## TEHAMA COUNTY PUBLIC WORKS

### ADDENDUM #2

#### TEHAMA COUNTY BUS SHELTER INSTALLATION PROJECT PLANS AND SPECIAL PROVISIONS COUNTY PROJECT NUMBER: 973037

- Addenda Issuance Date: March 26, 2015
- Bid Opening Date/Time: April 1, 2015 at 3:00 PM

SITE 4 LAYOUT PLAN

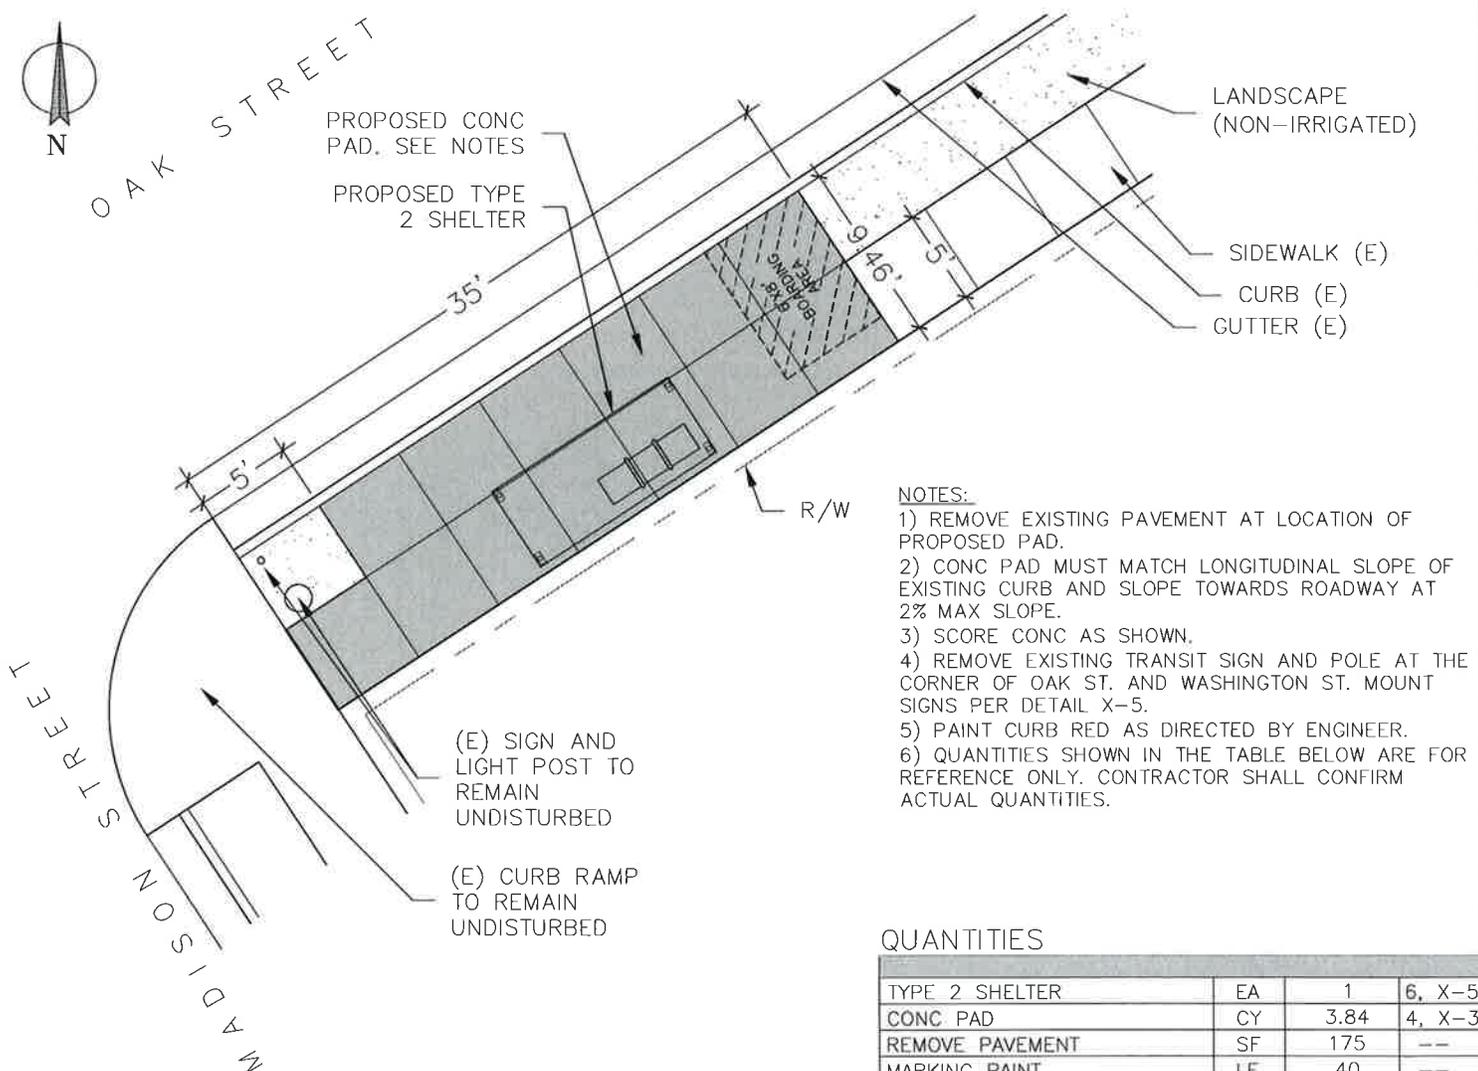
Refer to the project plans. Site 4 at Red Bluff City Hall has been relocated approximately 330' westerly to the corner of Oak St. and Madison St. Some estimated quantities have changed.

Replace plan sheet P-4, page 14 of 37 with attached "Exhibit 2-A"

**SITE 8 LAYOUT PLAN**

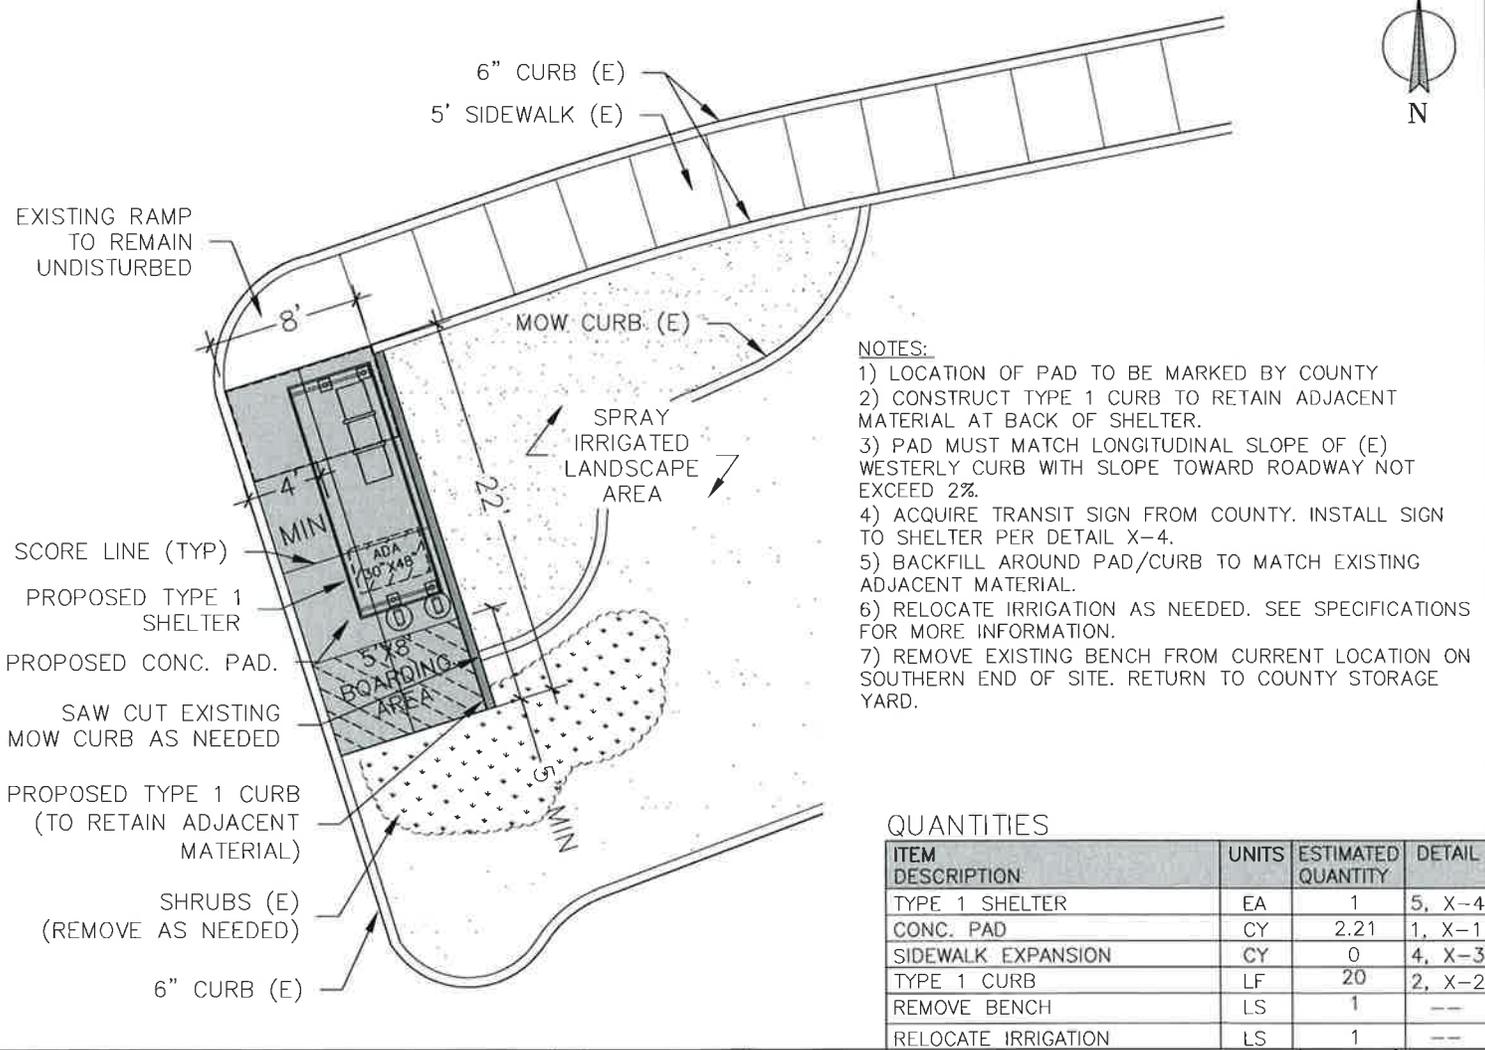
Refer to the project plans. The concrete pad at Site 8, Chevron Gas Station, has been lengthened from 20 feet to 22 feet. Some estimated quantities have changed.

Replace plan sheet P-8, page 18 of 37 with attached "Exhibit 2-B"

**SITE 9 LAYOUT PLAN**

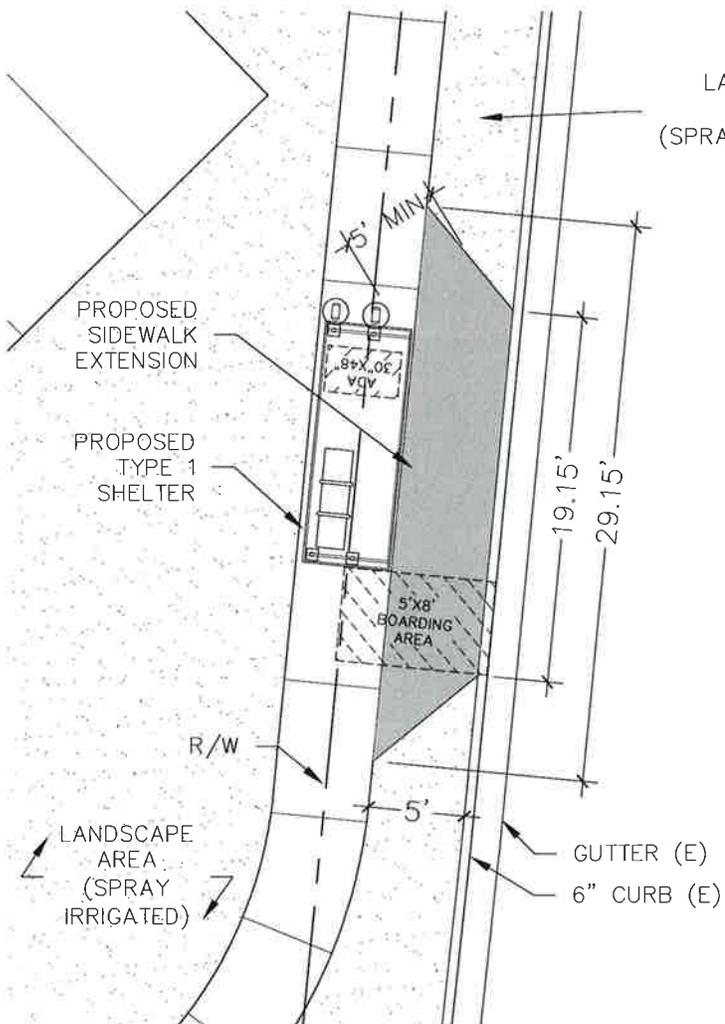
Refer to the project plans. Site 9 at Greenville Rancheria has been relocated approximately 30' northerly on Montgomery Rd. Some estimated quantities have changed.

Replace plan sheet P-9, page 19 of 37 with attached "Exhibit 2-C"

**SITE 10  
LAYOUT PLAN**

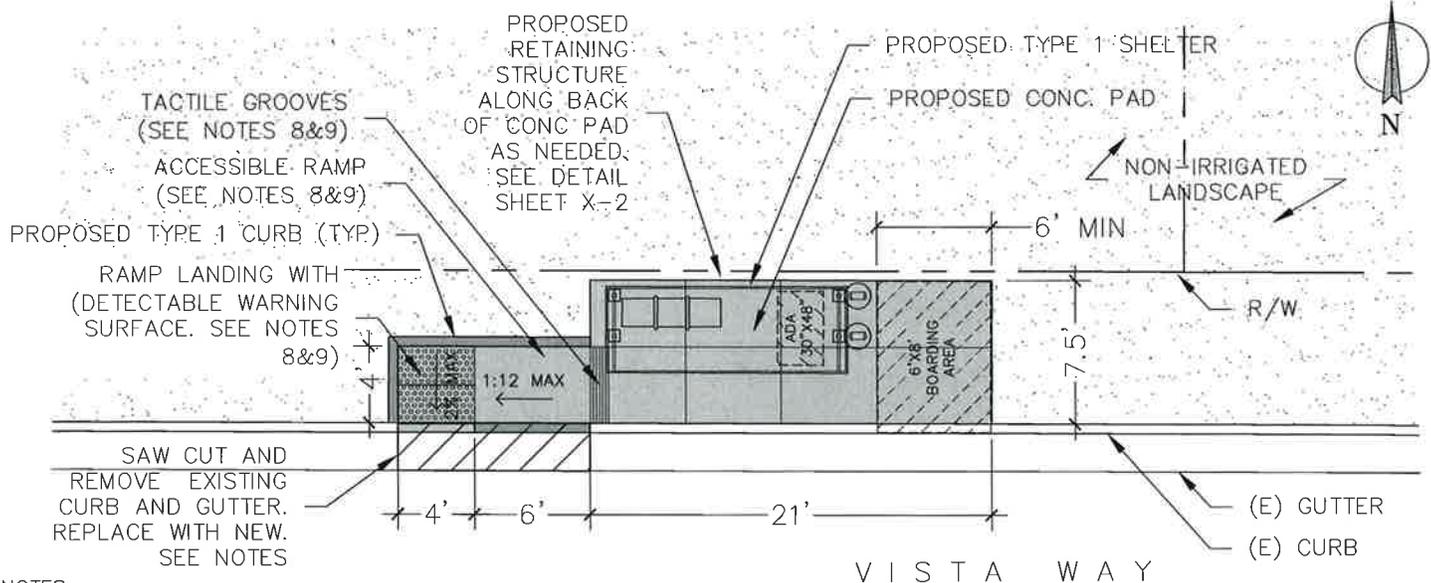
Refer to the project plans. Site 10 at Vista Way and Hornbeck St. has been relocated approximately 290' westerly to the corner of Vista Way and Bidwell St. Some estimated quantities have changed.

Replace plan sheet P-10, page 20 of 37 with attached "Exhibit 2-D"

**SITE 23 LAYOUT PLAN**

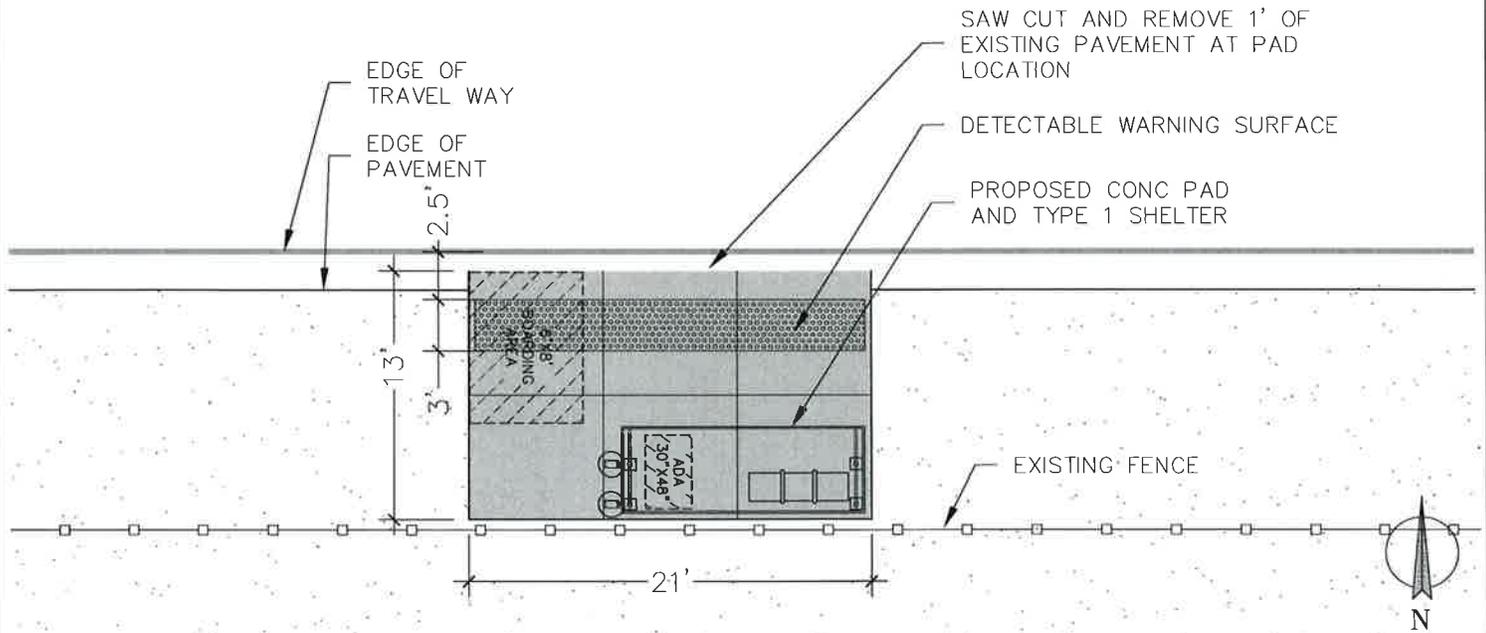
Refer to the project plans. Site 23 at 99W and Proberta has been relocated approximately 250' northwesterly on Flores Ave. Some estimated quantities have changed.

Replace plan sheet P-23, page 33 of 37 with attached "Exhibit 2-E"

**SITE 26 LAYOUT PLAN**

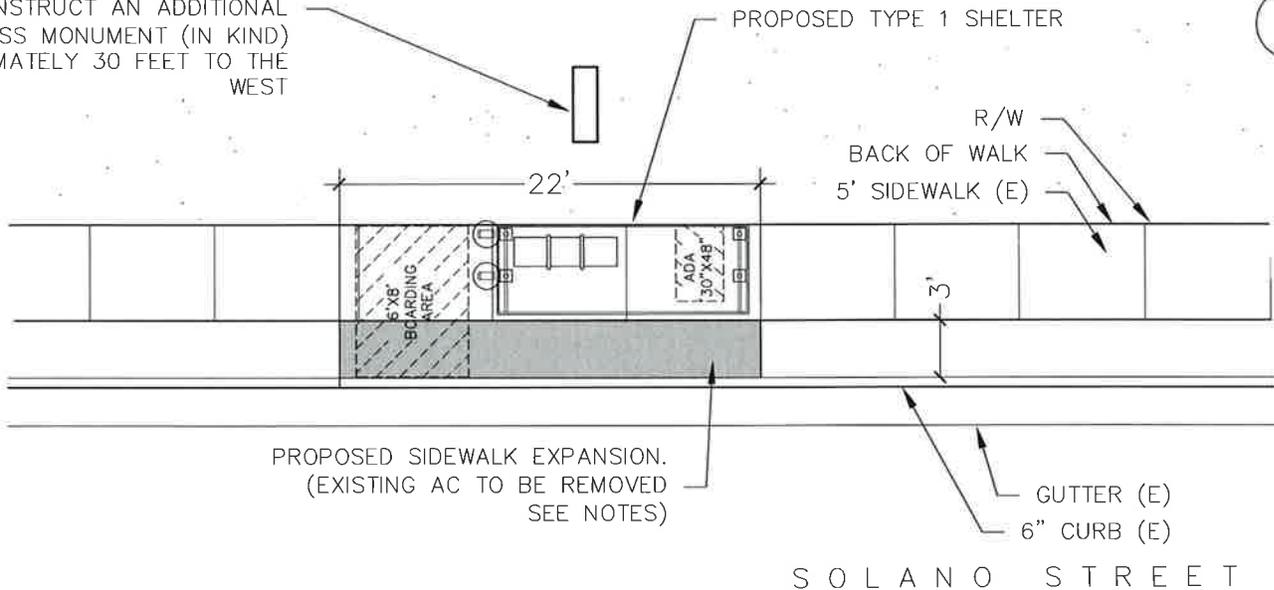
Refer to the project plans. Site 26 at Dollar Tree has been relocated approximately 110' easterly. Some estimated quantities have changed.

Replace plan sheet P-26, page 36 of 37 with attached "Exhibit 2-F"

**SITE 27  
LAYOUT PLAN**

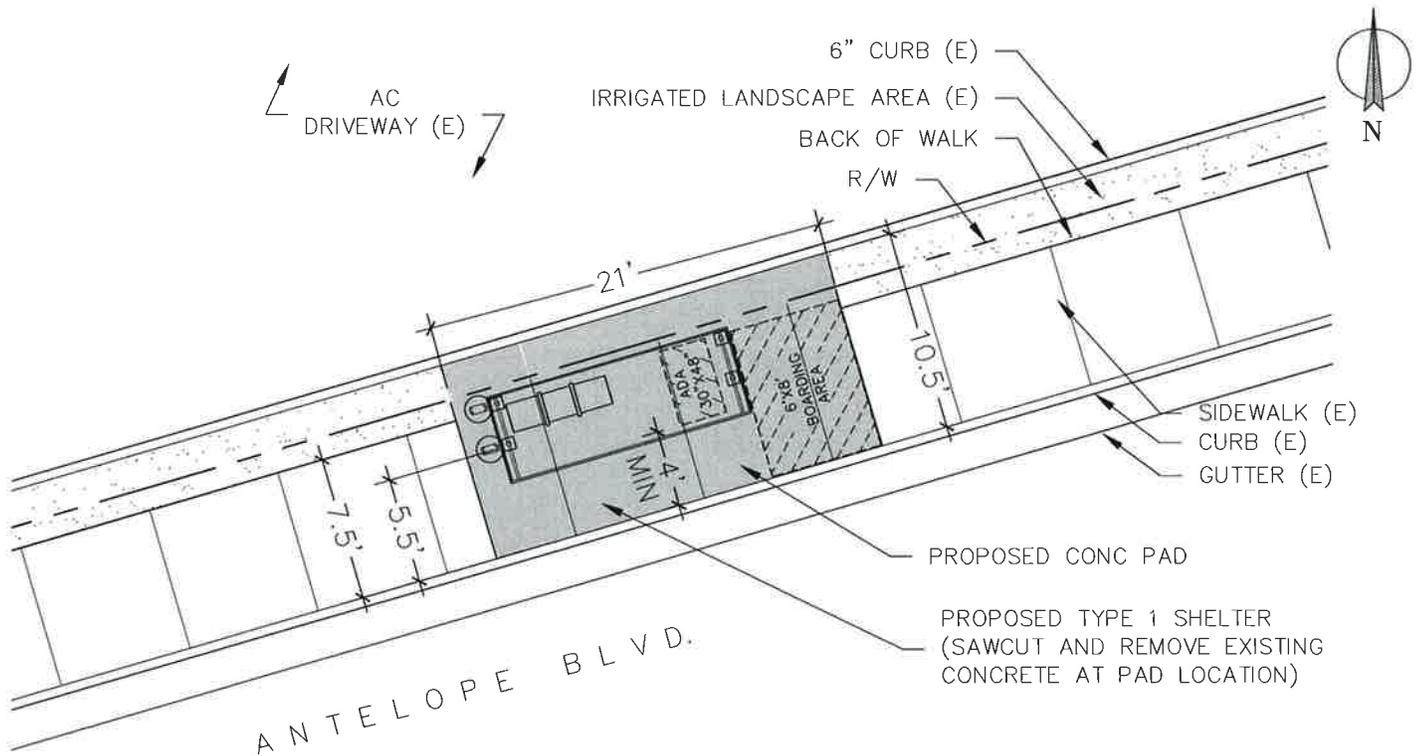
Refer to the project plans. The concrete pad at site 27, Shell Gas Station, has been widened from 8 feet wide to 10.5 feet wide. Some estimated quantities have changed.

Replace plan sheet P-27, page 37 of 37 with attached "Exhibit 2-G"

**SITE 28 LAYOUT PLAN**

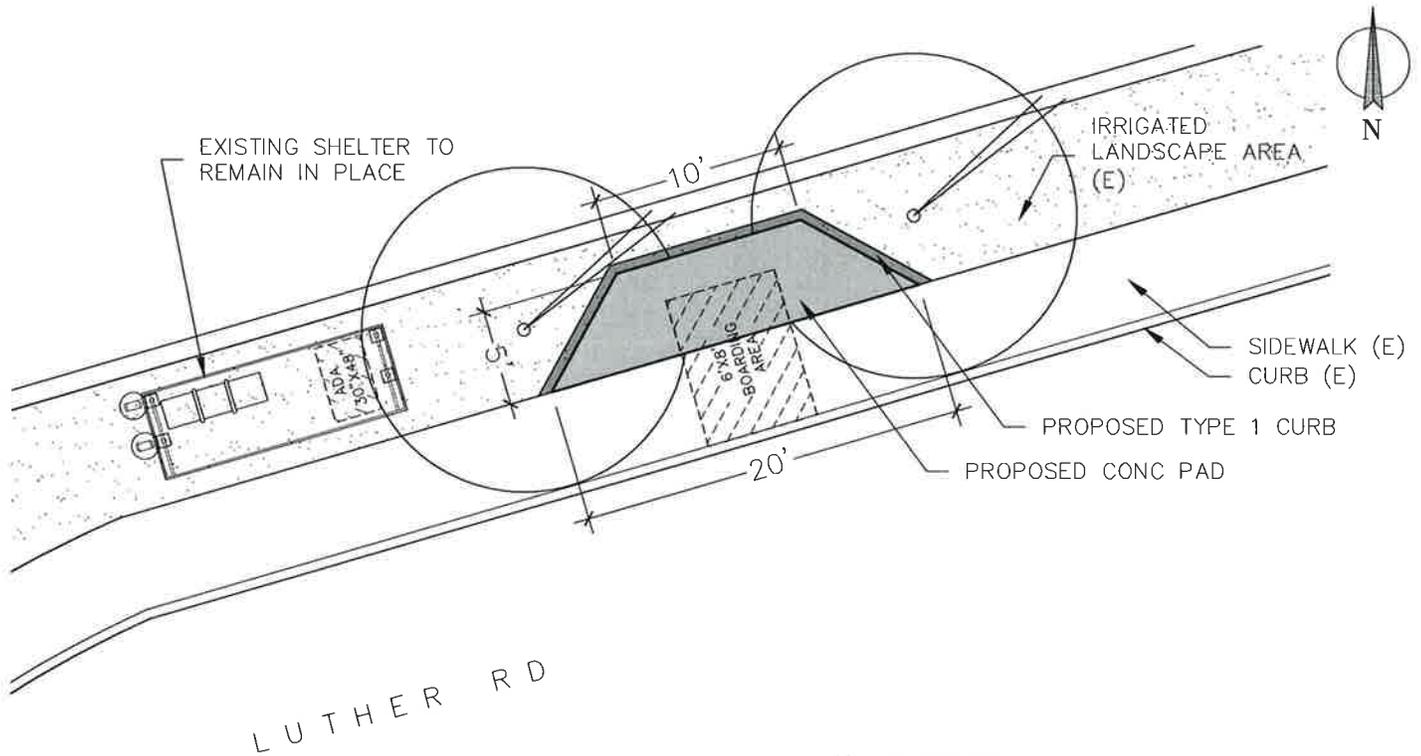
Refer to the project plans. An additional site has been added. Concrete pad and Type 1 curb improvements shall be added to the existing bus stop location located approximately 160 feet south of Luther Rd. in Red Bluff.

Project plans shall now include page P-28 "Exhibit 2-H"
